Madison West Neighborhood Association

**February 3, 2017**

**Re: Neighborhood Recommendations: The High Point – Raymond Neighborhood Development Plan Update**

**Signatures By Address Opposing the Jeffy Trail Street Extension**

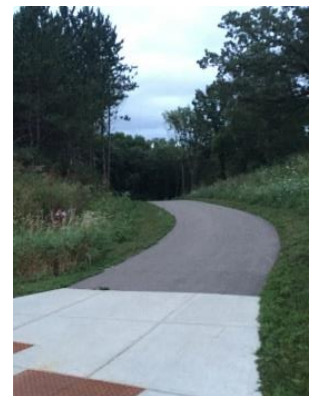
Consistent with Recommendation #1 and #3, and the prioritizations in Recommendation #4 and #5 , **the MWNA recommends that the updated Neighborhood Plan preserve the existing Jeffy Bike Path and preserve as a park the unique conservancy land adjoining the Ice Age Junction Natural Resource area. To preserve these assets, the MWNA recommends that the updated Plan not include the previously proposed southern extension of Jeffy Trail which will serve no new development.**

It has been documented that the extension of the street is overwhelmingly opposed by the neighborhood it is intended to serve. That opposition is based on neighborhood residents’ determination that the impacts on the neighborhood’s auto-free *bike and pedestrian connections* via the Jeffy Bike Path and Ice Age Junction Bike Paths to other neighborhoods and the neighborhood’s use of the unique conservancy land adjoining the Ice Age Junction Natural Resource area as a park do not to justify the small benefit created by an *automobile connection* to Raymond Road.

In Fall 2014 and again in Fall 2015, City Engineering proposed spending over \$500,000 to replace the newly built Jeffy Bike Path with a street connection to Raymond Road. Because of the significant value the neighborhood placed on preserving the Jeffy Bike Path and the conservancy land adjacent to the Ice Age Trail that the street extension would replace and traverse, the neighborhood organized to oppose funding for the project. In 2015, over 420 individuals that live in the neighborhood, including 80% of the single family homes of Jeffy Trail, Bedner Road, Trevor Way, Flagstone Drive, Ethan Circle, Mica Road, Quartz Lane, Dolomite Lane, Shale Drive, and Talc Trail, joined a letter opposing the street connection. That joint letter presented to the City of Madison Common Council in November 2015 stated **“THE NEIGHBORHOOD – Hawk’s Creek, Stone Crest Estates, and Mill Creek Estates Subdivisions – that is the intended beneficiary of the Jeffy Trail street extension overwhelmingly opposes the street extension.”** As a result of neighborhood opposition, the Common Council in 2014 and again in 2015 did not approve funding for the street project for the subsequent budget year. In 2016, City Engineering recommended that the street project was not a priority and did not recommend funding for the 2017 budget year.

Table 1

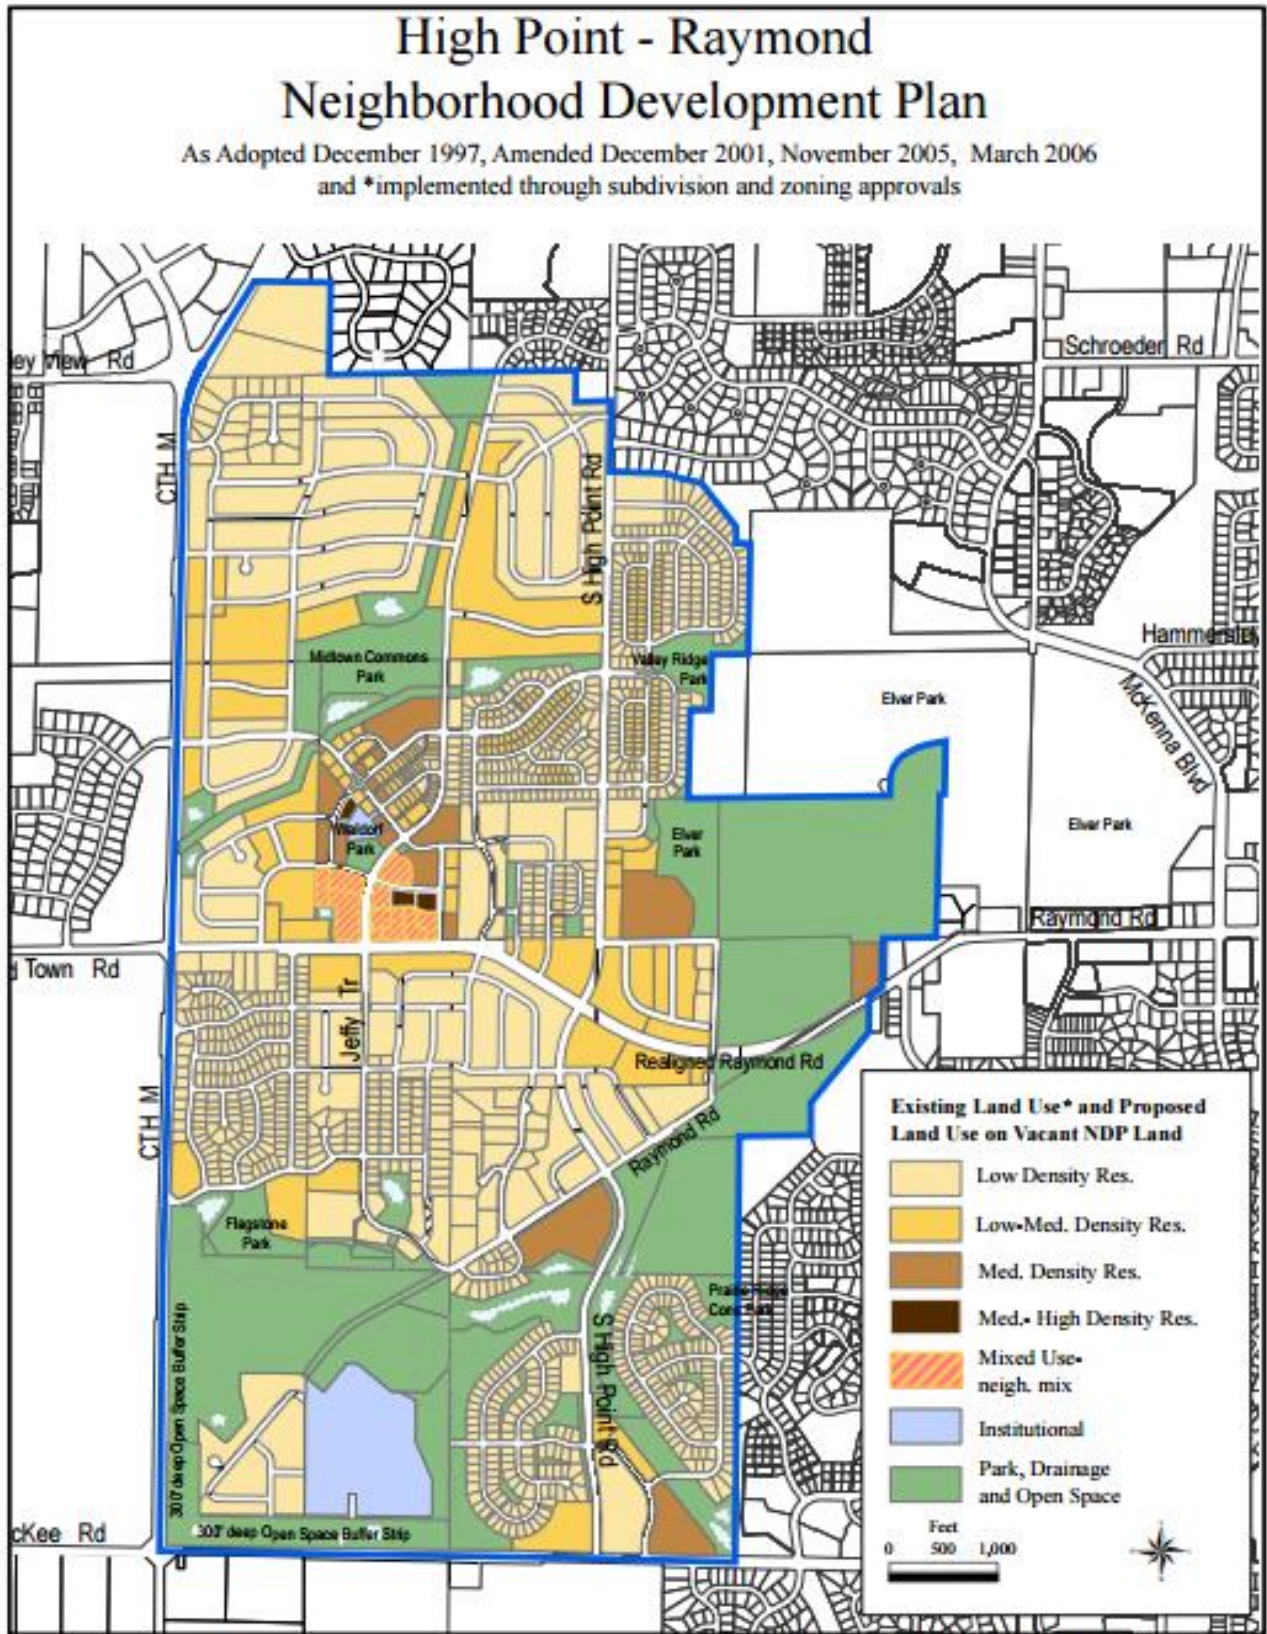
The current Neighborhood Plan last amended in 2006 provides an initial baseline for land use and density (see Table 1 – Proposed Land Uses). However, completed developments and those currently under construction have changed those mixes. **We recommend that the updated Neighborhood Plan narrative provide data comparing the proposed land use and density mixes (including data on total residential units for each density type) in the neighborhood between what was proposed in 2006, what those mixes are currently (completed plus in process construction), and what the mixes would be in the proposed updated Plan. We also recommend that comparisons be provided with other similarly situated suburban neighborhoods, such as the new Grandview Commons.**

# Recommendation 4

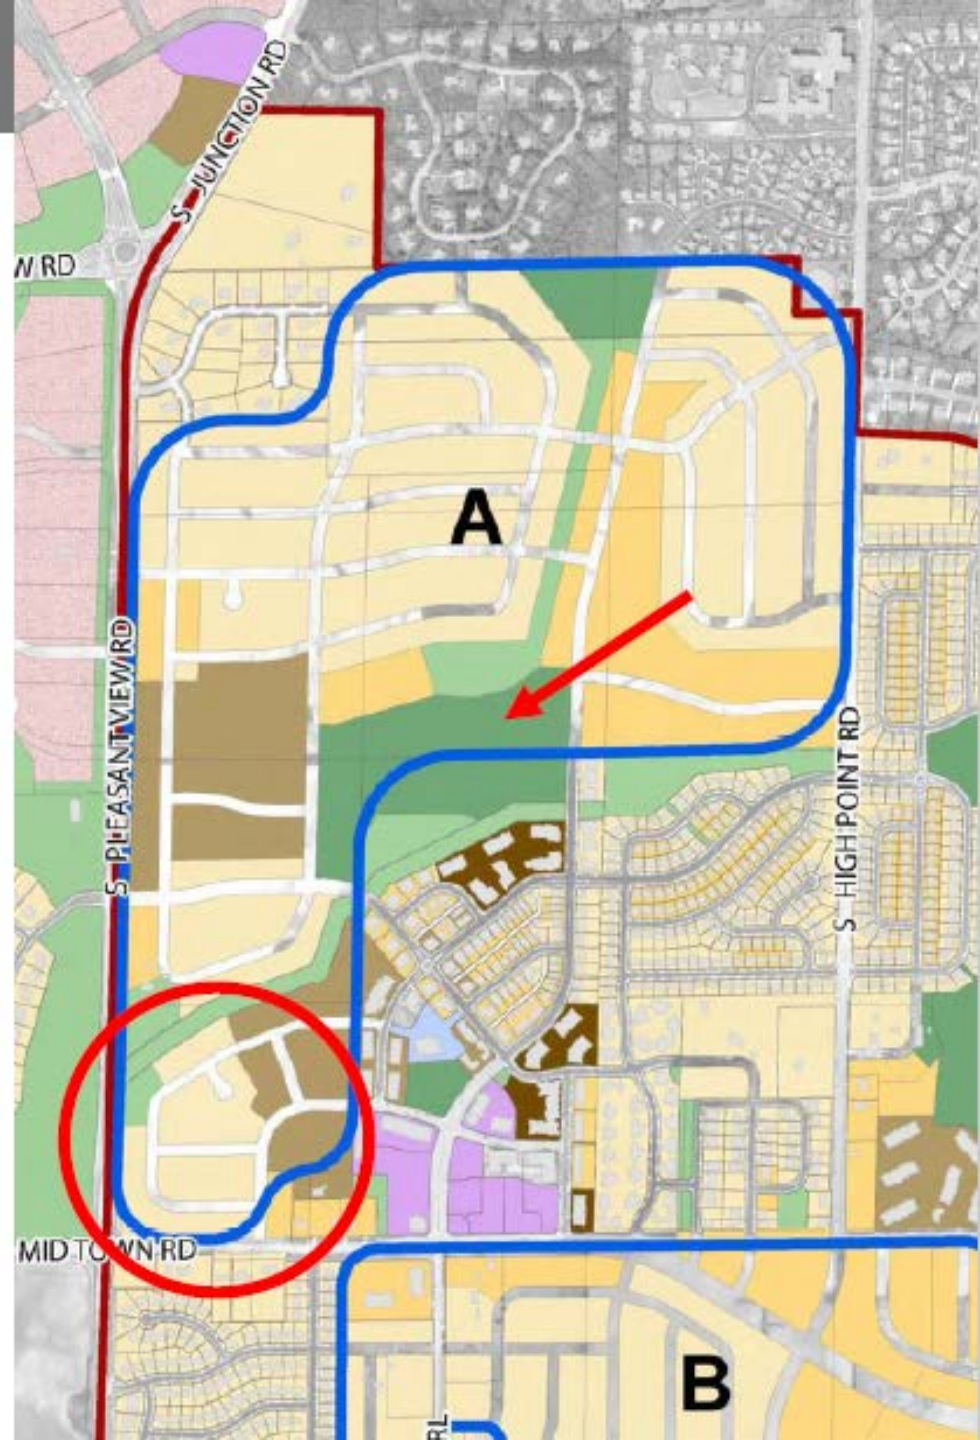
- Plan does not address or prioritize the order of supporting infrastructure or development
  - Significant impact to efficient access and transit
  - Affects all modes of current/future transportation and multi-modal options
  - Places highest desired amenities at risk
- **In order to proceed with “smart” development, we believe that the updated plan should articulate and prioritize a strategic order of development, so that the full intent and design of the Neighborhood Plan is realized as development in the neighborhood progresses not just when it is completed.**
